City of Plymouth Planning Commission Regular Meeting Agenda Wednesday, December 13, 2023 – 7:00 p.m. City Hall & Online Zoom Webinar

**Special Land Use
Site Plan Review
For
Plymouth, Michigan**

Applicant:	Straight Family Hospitality 1020 W. Ann Arbor Rd. Plymouth, MI 48170
Project Name:	The Drift Restaurant
Plan Date:	August 23, 2023
Latest Revision:	November 21, 2023
Location:	1020 W. Ann Arbor Road
Zoning:	ARC – Ann Arbor Road Corridor District
Action Requested:	Special Land Use and Site Plan Approval
Required Information:	Any deficiencies are noted in the report.

20 ENLARGED PLAN AT BUILDING
 24" x 36" SCALE: 1/8" = 1'-0"
 11" x 17" SCALE: 1/16" = 1'-0"

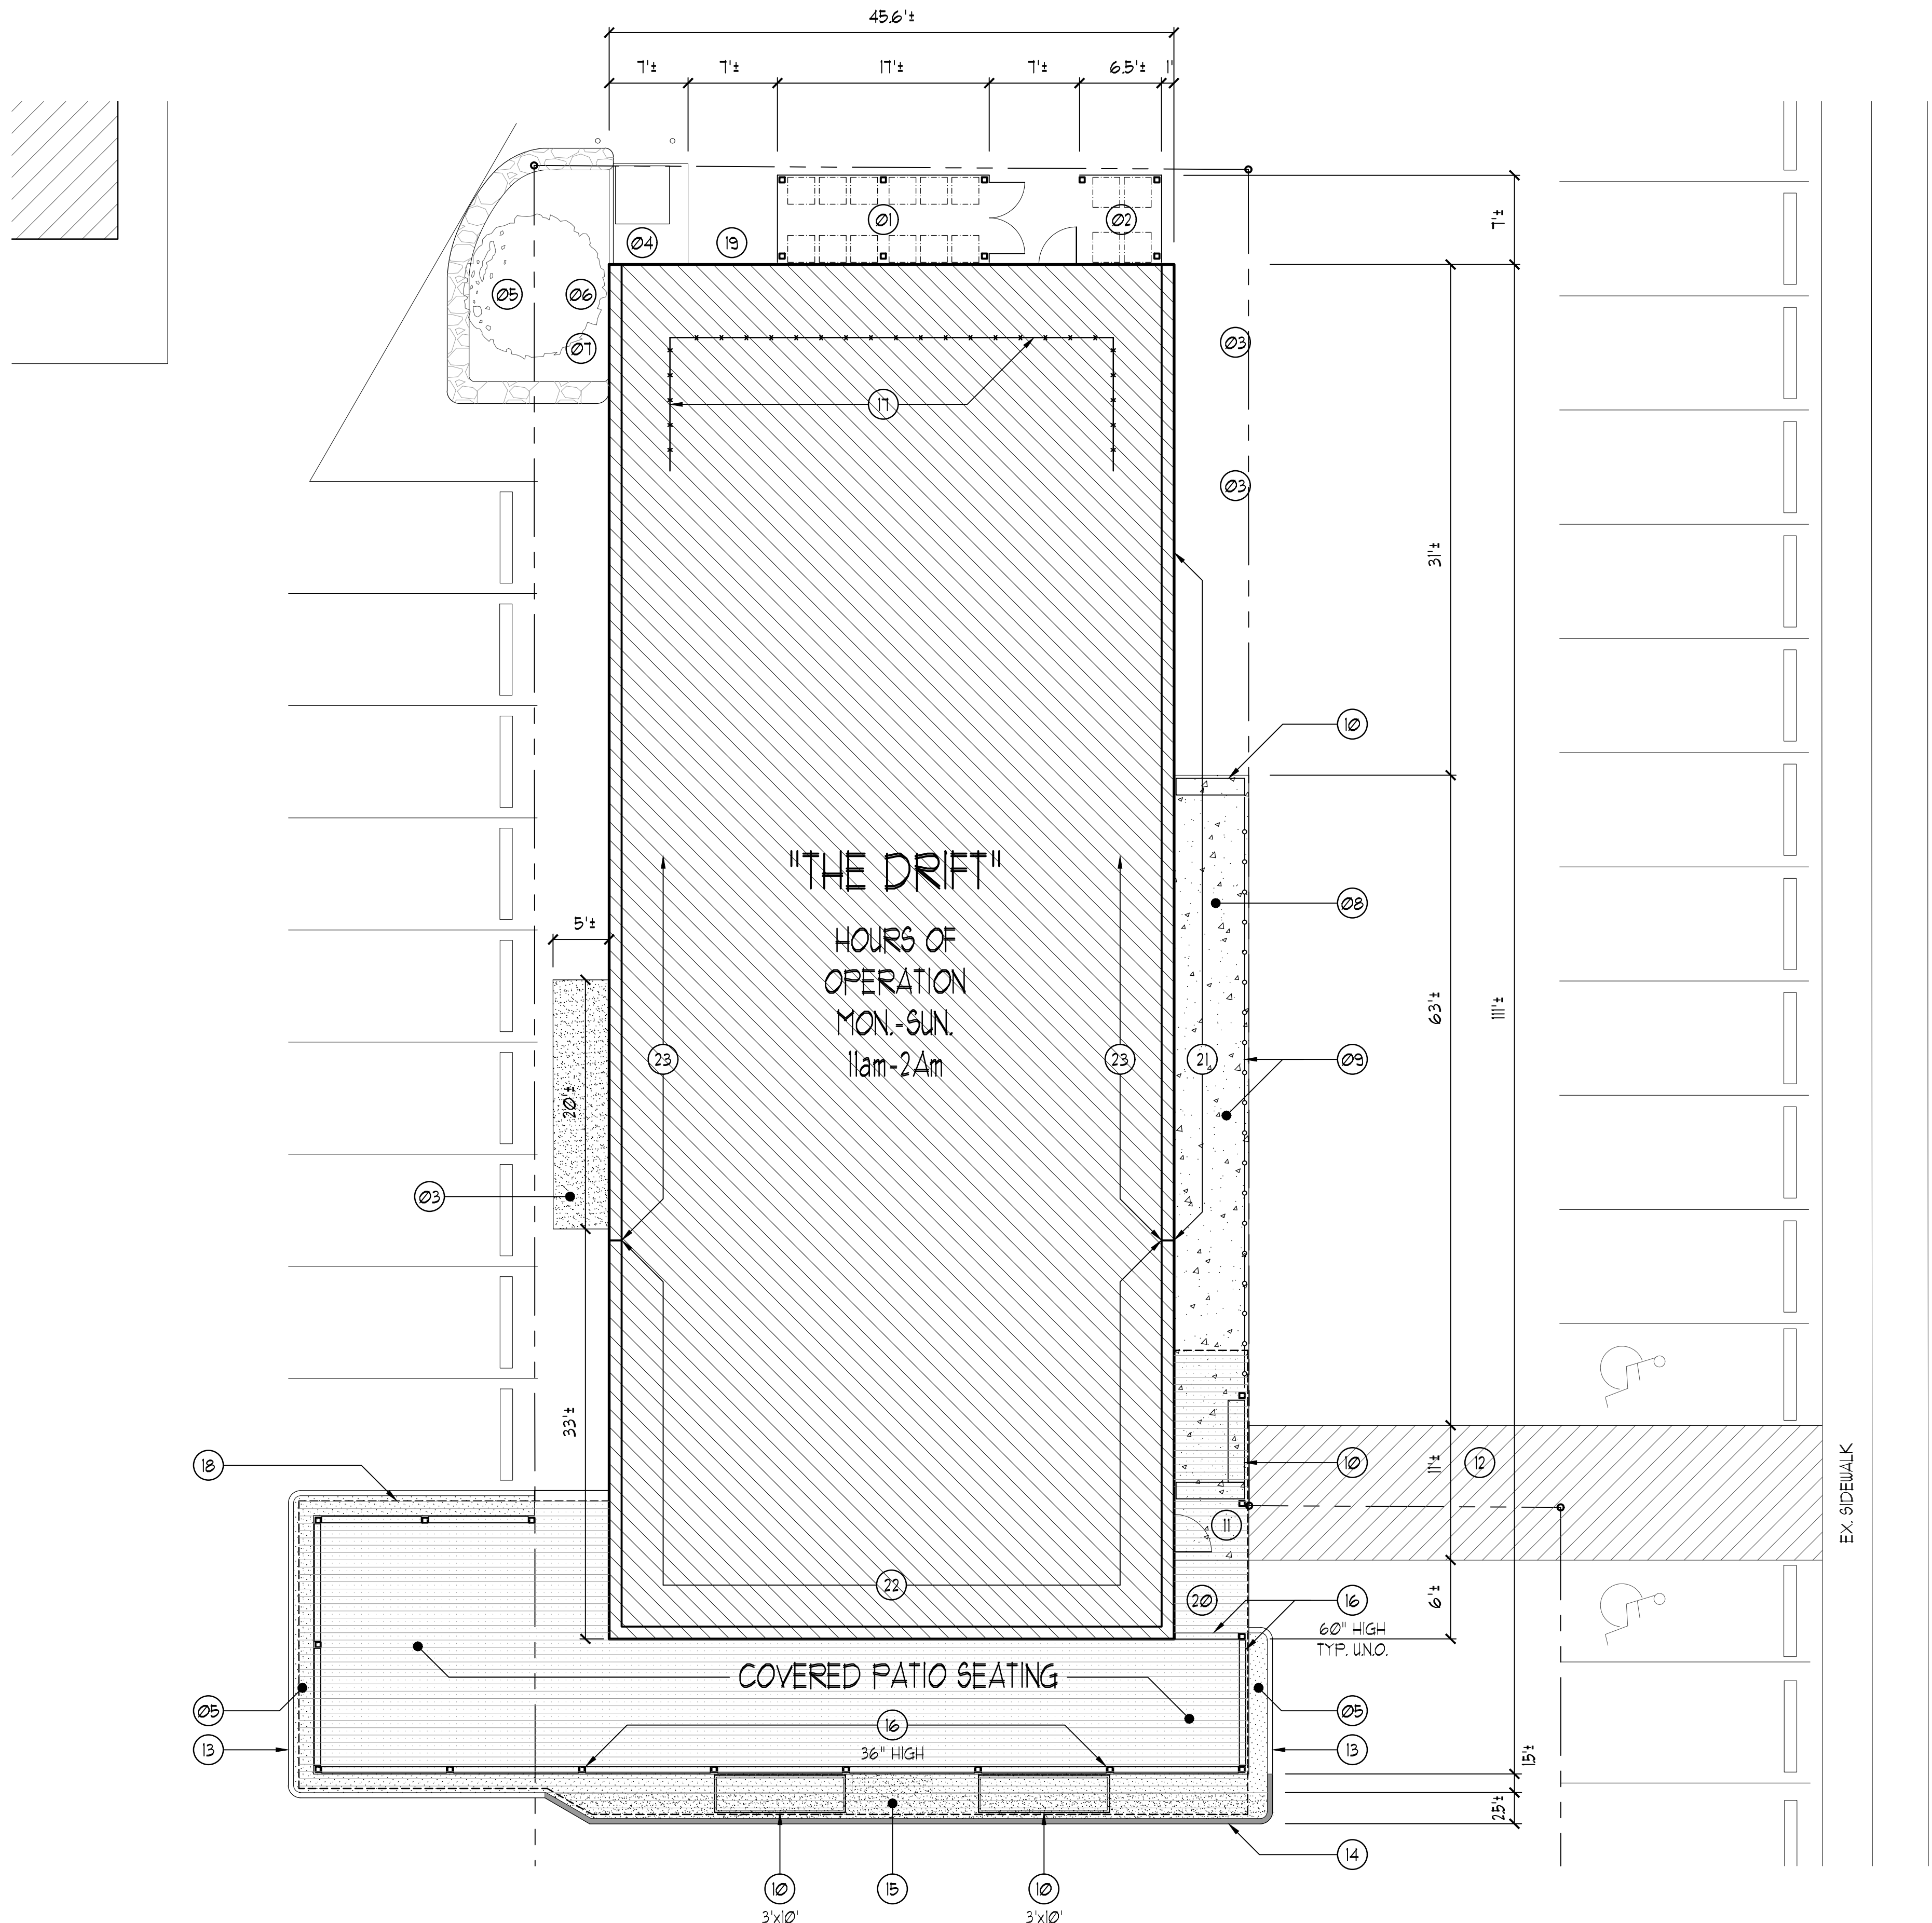
Note that the "Deliveries" description on Sheet 2 states that the operation will open at 10:00am. The proposed hours of operation should be confirmed, in writing.

Items to be Addressed: 1) *Planning Commission to discuss how the proposed architecture "fits" into the Ann Arbor Road Corridor character, as required by the Master Plan and ARC District. 2) Confirm hours of operation, including reference in "Deliveries" description on Sheet 2.*

Loading/Unloading. The ordinance requires one (1) loading/unloading space for the proposed restaurant. A loading/unloading space is shown on the plans on the east side of the shopping center building. The “Deliveries” description on Sheet 2 also states that smaller delivery vehicles may park directly behind the restaurant through the building’s rear entrance. They expect deliveries will occur four (4) times a week.

The revised plans show outdoor dining on the Harvey St. side of the building. These tables will be enclosed with “removeable” fencing. These tables are directly in the line of cars backing out of the parking spaces along Harvey St., as well as vehicles traveling the adjacent maneuvering lane. There isn’t even a curb between this dining area and the vehicle traffic area. In our opinion, this configuration is insufficient unless the removeable fencing can provide adequate protection to the diners from wayward vehicles. The plans should provide details of how removeable fencing can provide a sufficient protective barrier between vehicles on this side of the building and patrons at the dining tables.

The plans have been revised to show the location of an existing electrical transformer, and no screening of the transformer is shown on the plans. The Planning Commission requested that robust landscaping be proposed. The transformer is directly next to a landscape island to the west, and two shrubs that will reach about 3-4 feet tall would help to screen the transformer from the west side of the parking lot. Sheet 2 of the plans states that rooftop equipment will be provided with proper screening that conforms to the ordinance. The rendering of the rear façade of the building shows parapet walls on the east and west side, and some type of internal screen on the rooftop, which appears to be shorter than the parapet walls.

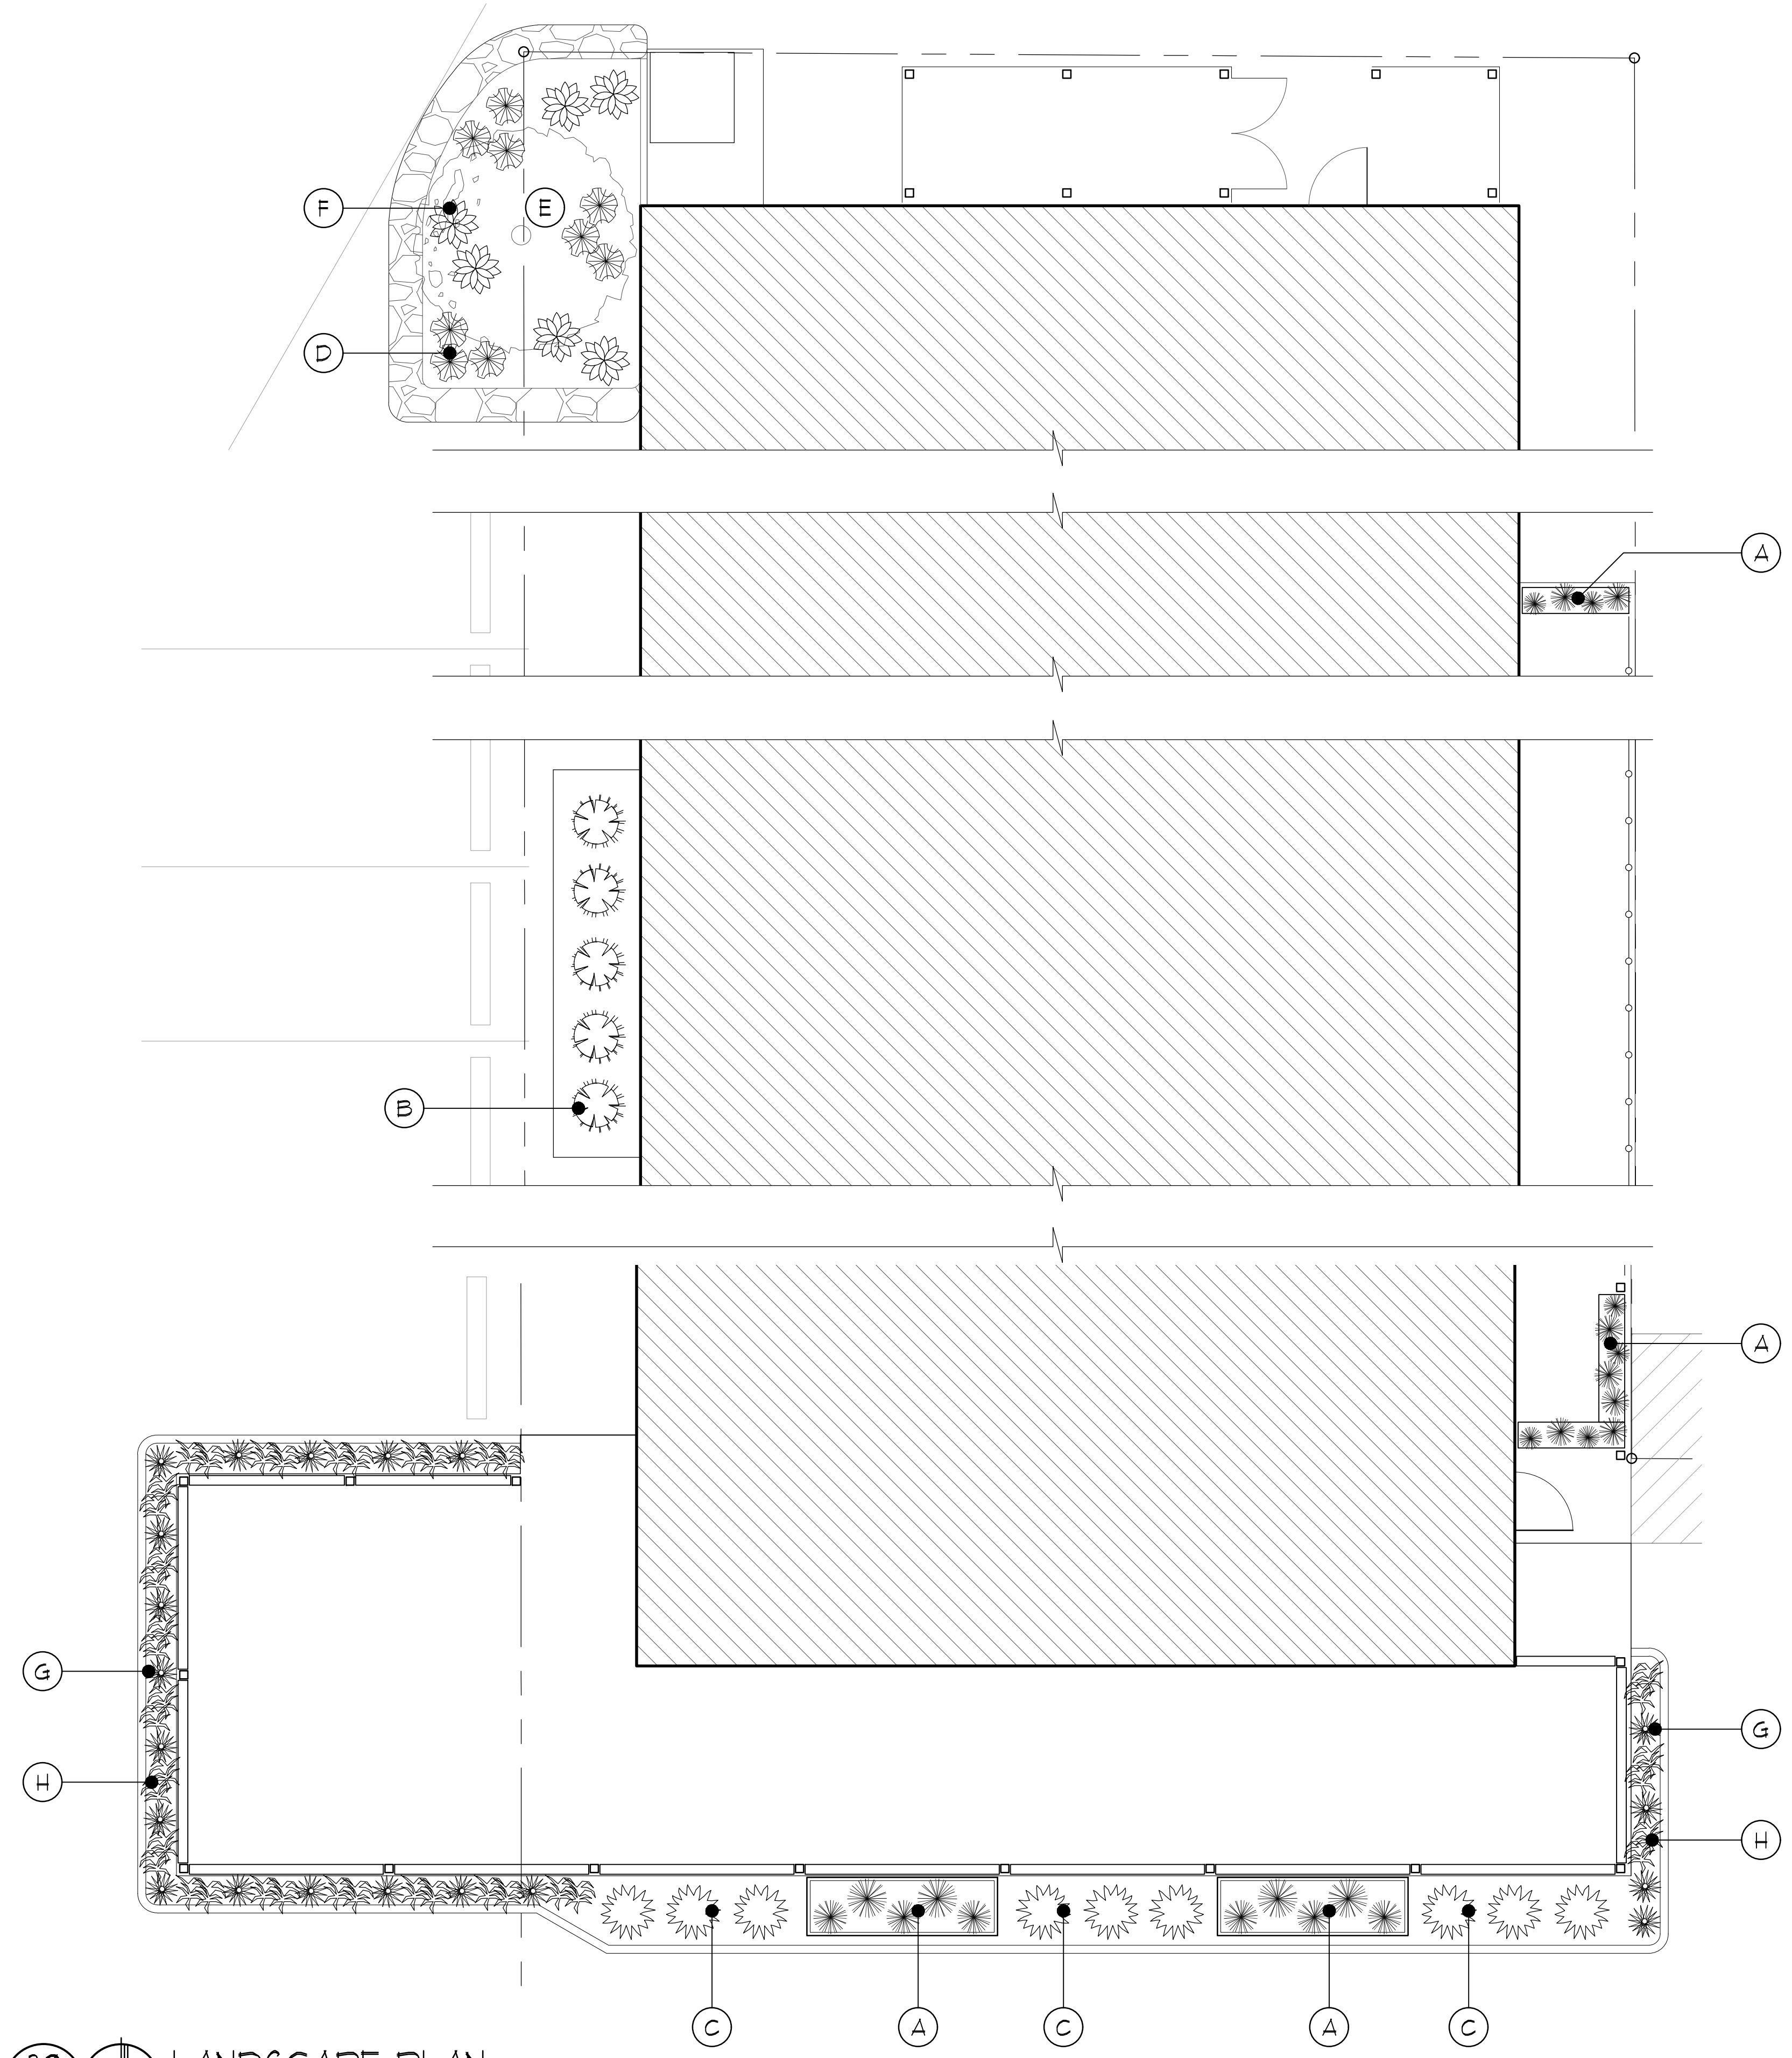
In our opinion, these two sections conflict to some degree. When a conflict occurs, the ordinance states that the “stricter provision applies” (Sec. 78-5). We consider the Ann Arbor Road Streetscape Prototype requirements to be the stricter of the two, and they should be applied to the area fronting the subject site along Ann Arbor Rd. We also think implementation of these requirements will conform to the Planning Commission’s request for robust landscaping on the site. Sheet 3, *Landscape Plan*, doesn’t include this portion of the site, and should.

Items to be Addressed: 1) Provide landscape plan that illustrates screening features required by Sec. 78-171, Ann Arbor Road Streetscape Prototype, and Sec. 78-203 along the subject site’s Ann Arbor Rd. frontage. 2) Replace Fineline Buckthorn with non-invasive alternative.

Exterior Lighting Plan

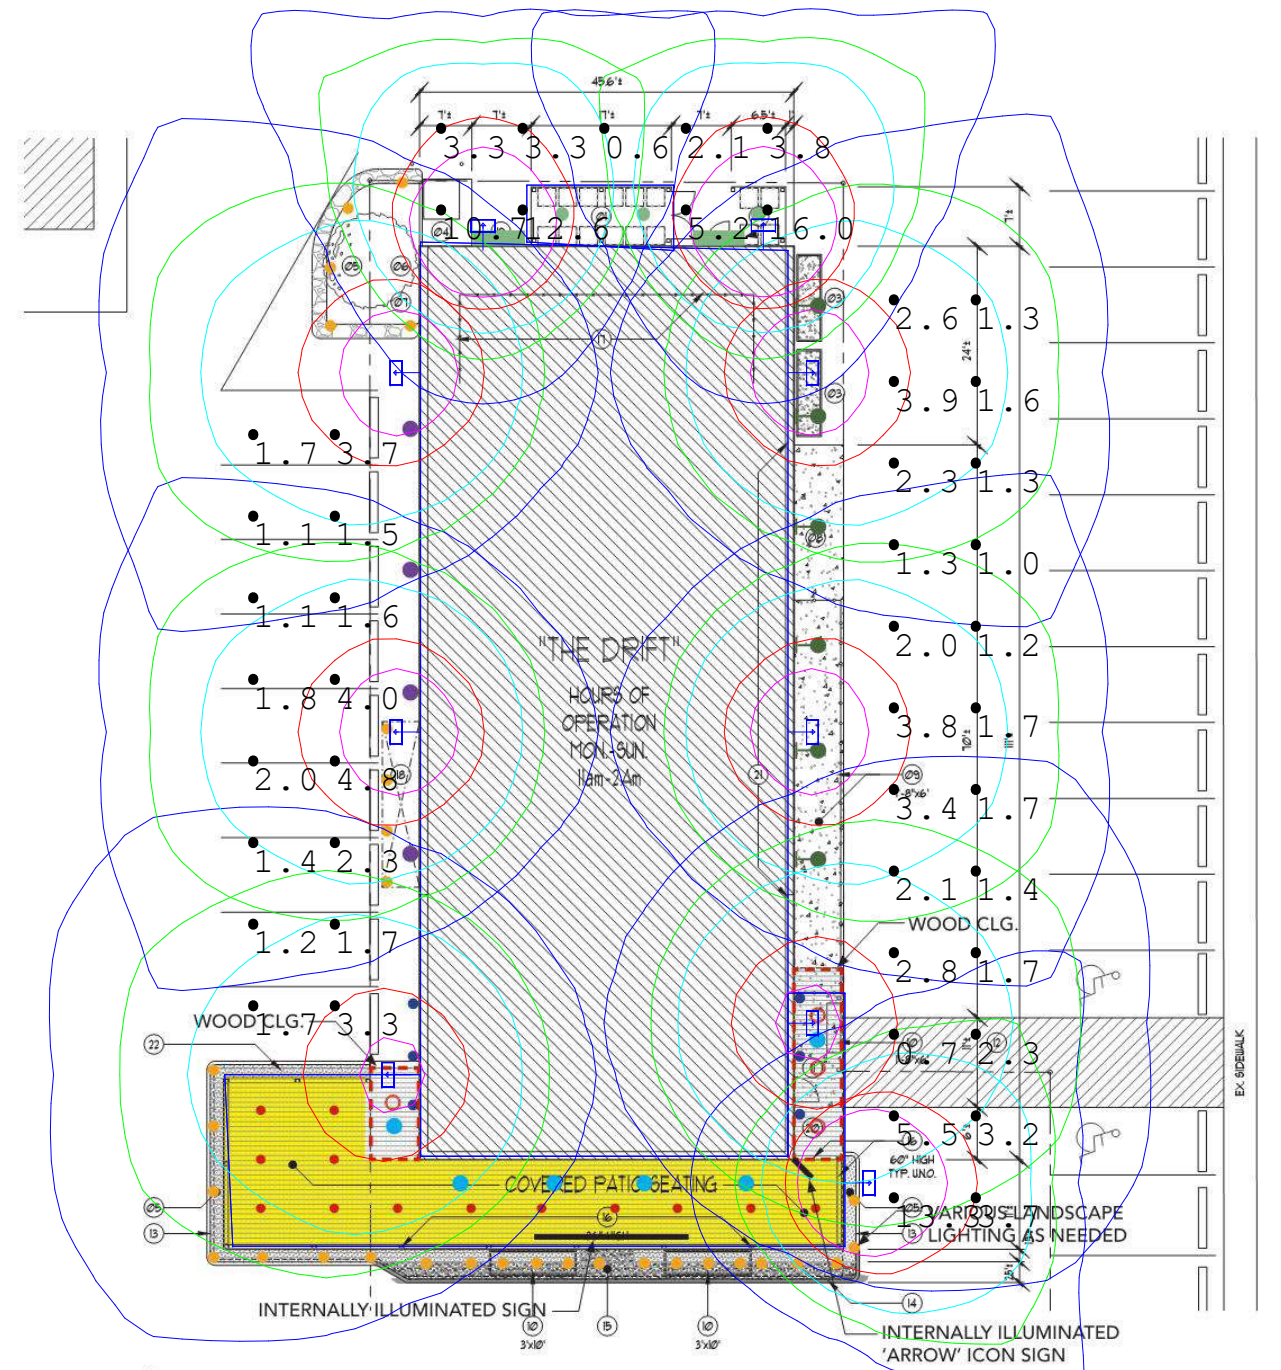
The photometric plan appears to only consider the utilitarian wall-pack type light fixtures. The lighting levels shown meet ordinance requirements; however, this plan does not illustrate all the lighting types shown on the building elevations, and needs to be amended to include all fixtures.

Items to be Addressed: 1) Provide manufacturer information for goose-neck, canopy, and fixture on west facade. 2) Include all fixture types on the photometric plan. 3) Remove light fixtures that illuminate the front façade of the building.
